1435 - P095

Bedroom//Existing///Plan_1:20

Rev	Date	Notes
A	23.06.15	Radiator added and joinery removed .

Master Bathroom//Existing//Elevation 2_1:20

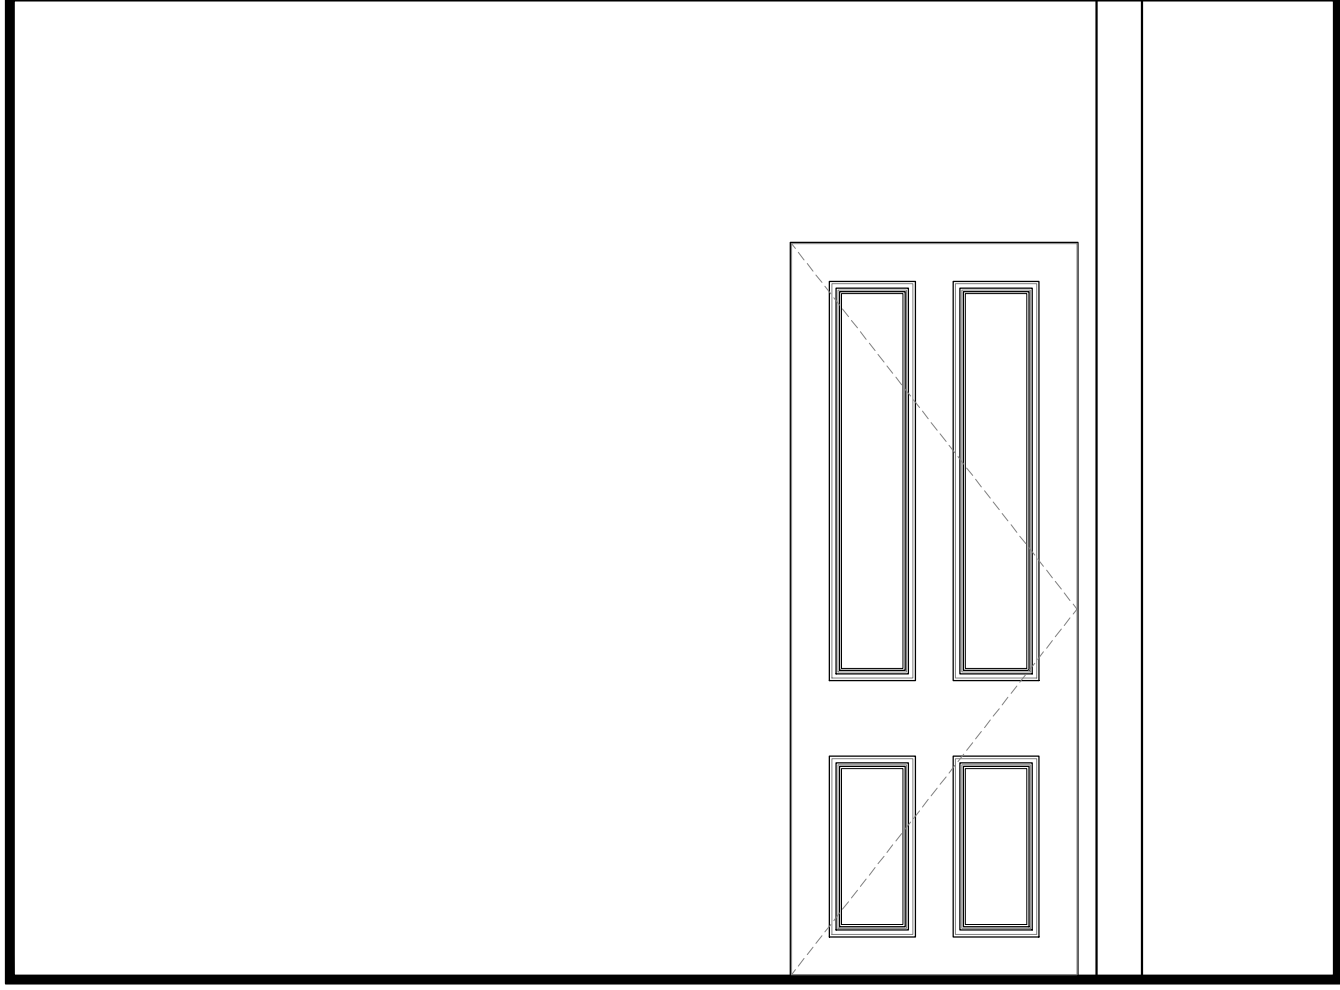
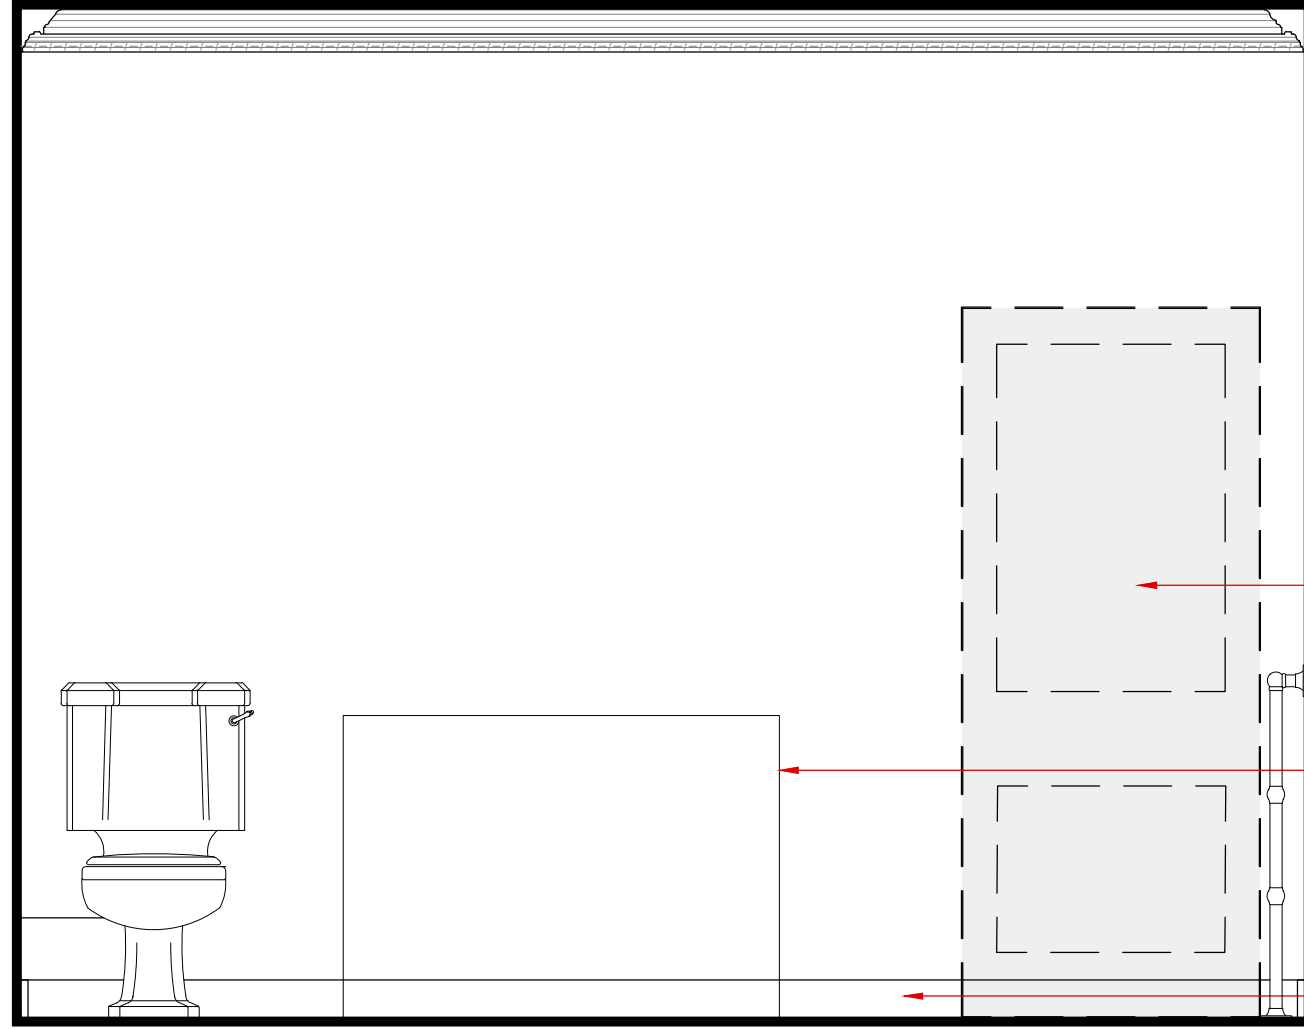
Proposed door to match D.1.06. Door to be fixed shut. Wall pilaster to be flushed out within bathroom.

Proposed freestanding unit.

Master Bathroom//Proposed//Elevation 3_1:20

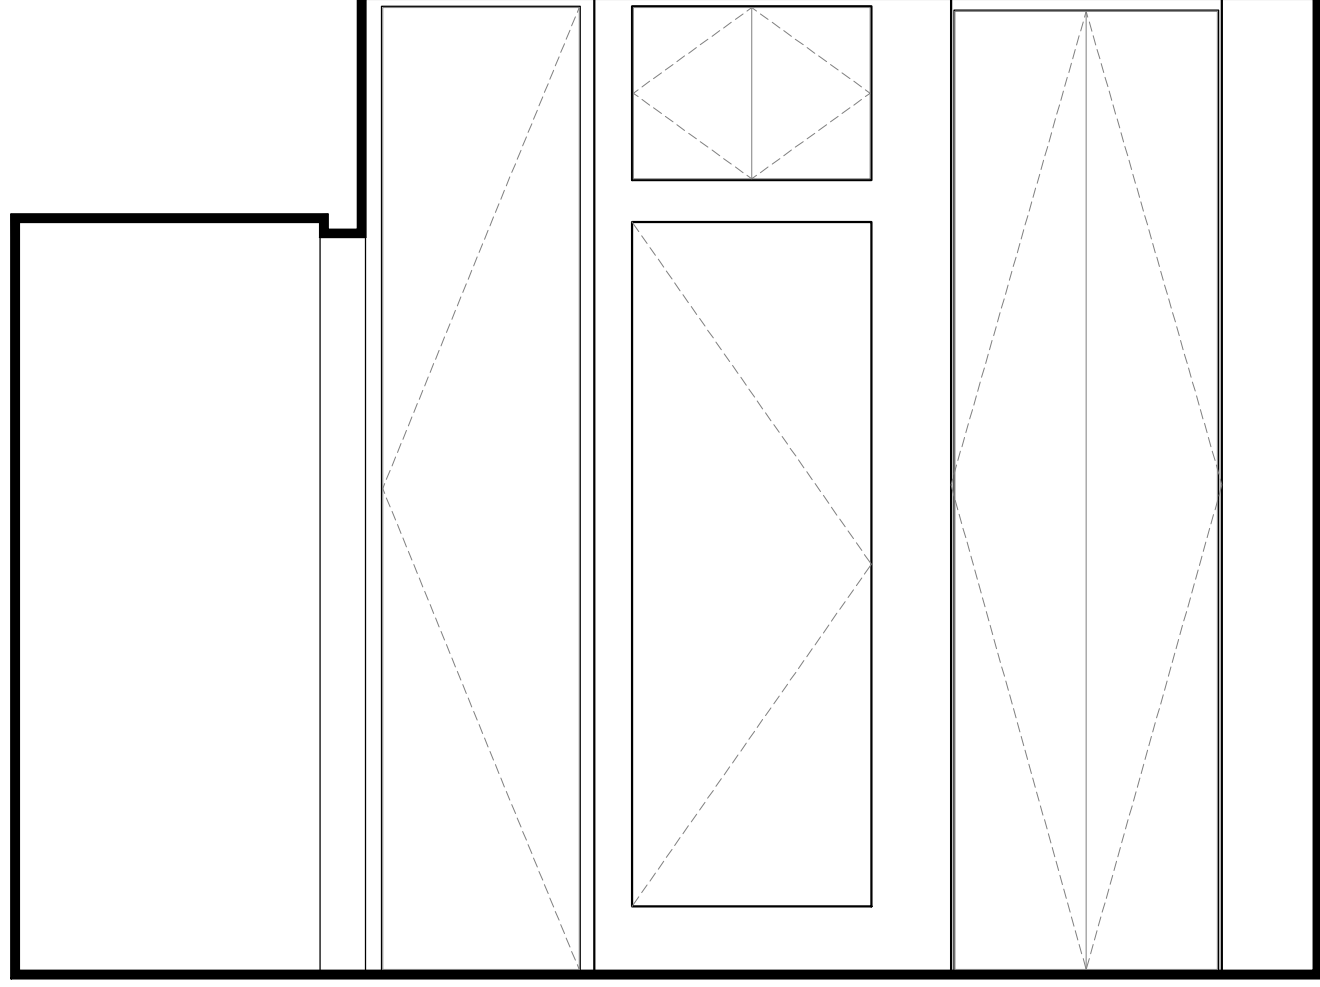
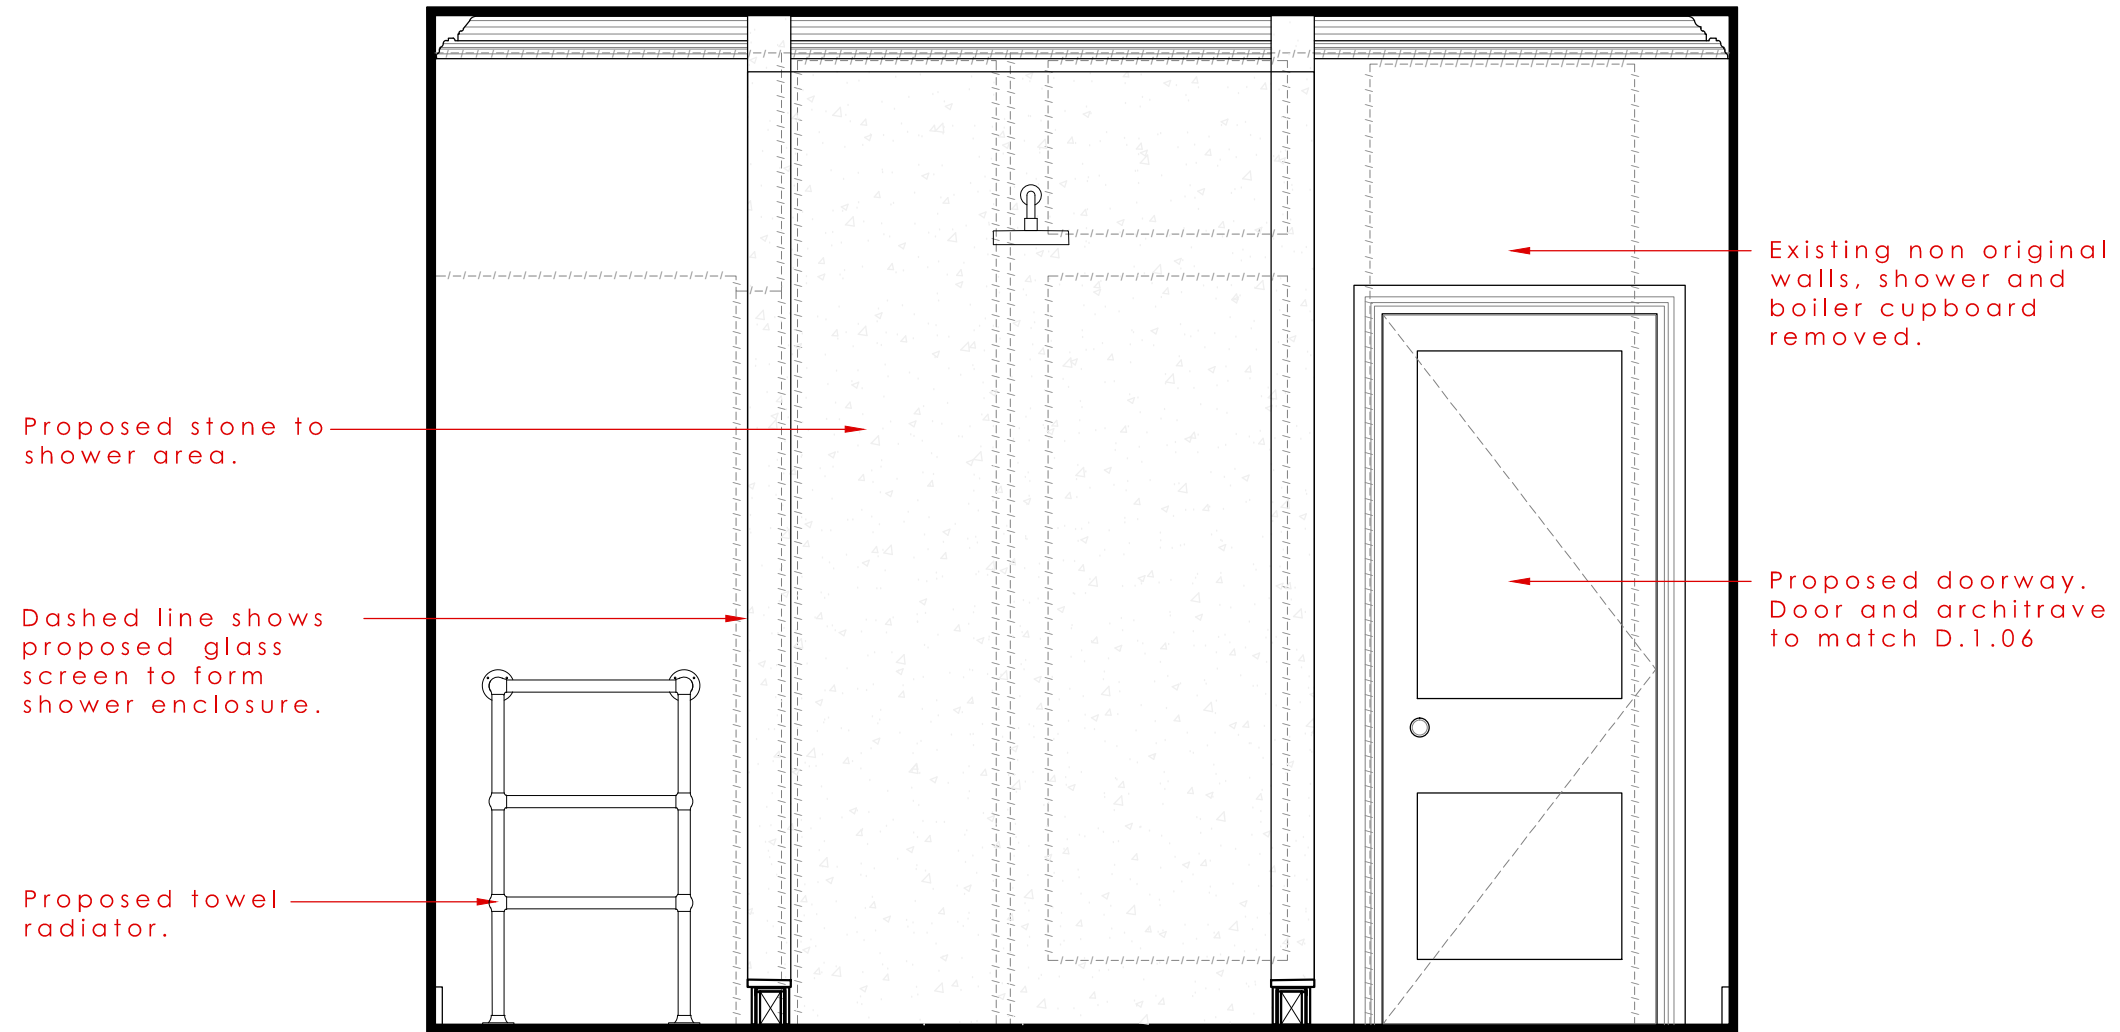
Proposed skirting to match Dressing Room.

Rev	Date	Notes
A	23.06.15	Tiling changed to stonework.

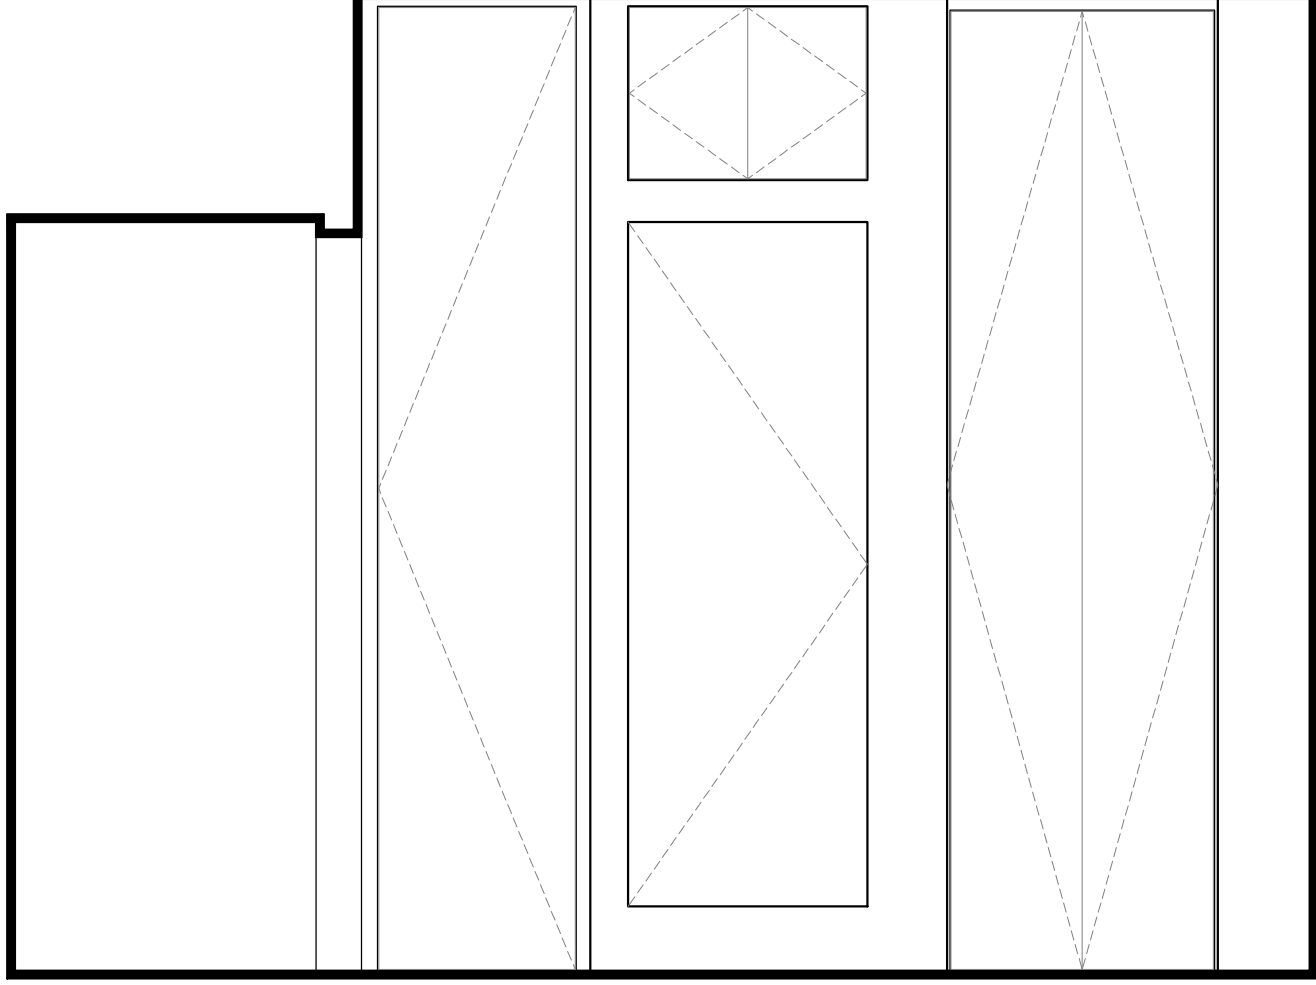
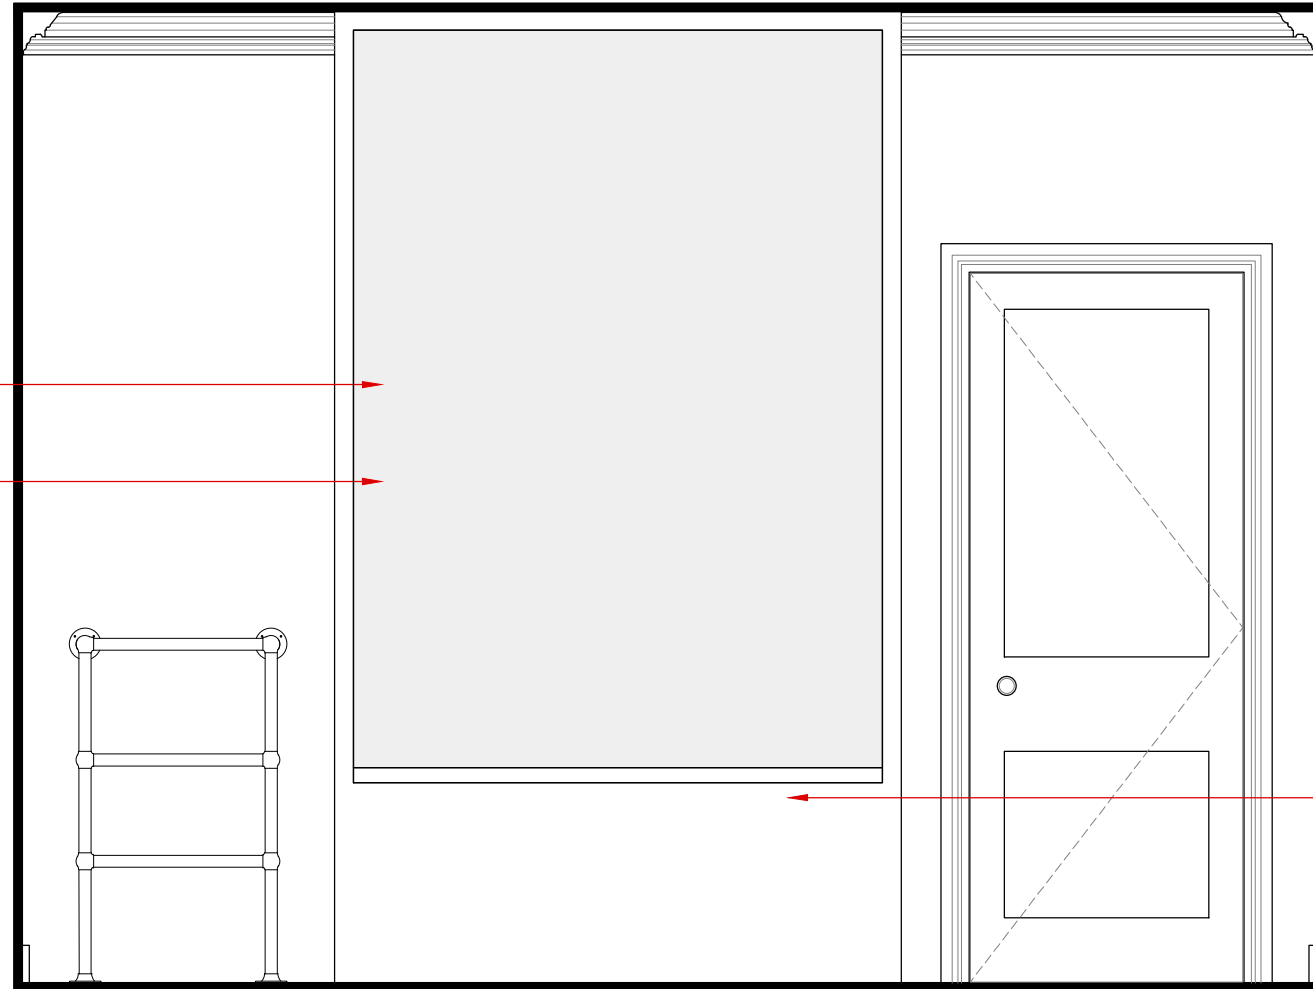
Proposed single glass panel.

Proposed full mosaic tiling.

Proposed studwall to house glass panel.
studwall to form shower enclosure.

Rev	Date	Notes
A	23.06.15	Tiling changed to stonework.
